CH100-CE/CH130-CE

Chopper Replacement

Field Service Bulletin
(P/N 804510)

Revision 0 – September, 2002

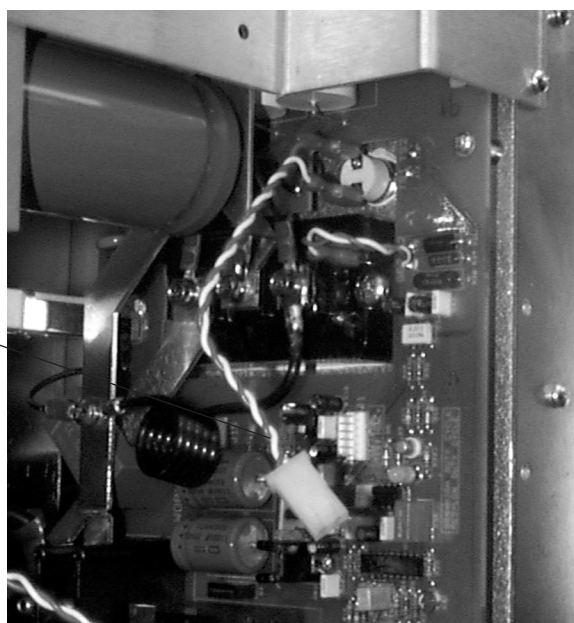
Replacement of the chopper. The connectors on the wire group from the temperature switch have been changed. The wire group included in this kit is only needed for power supplies made before September 2002.

The new chopper has this wire group attached to the temperature switch.

Part Number 129313

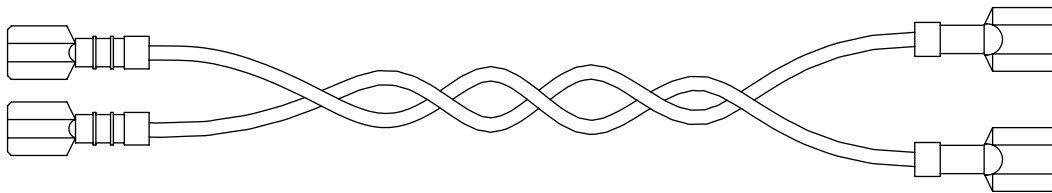
If the wires from the power supply have two red connectors (see picture below), remove the wire group (shown on previous page) from the new chopper and replace with part number 120313.
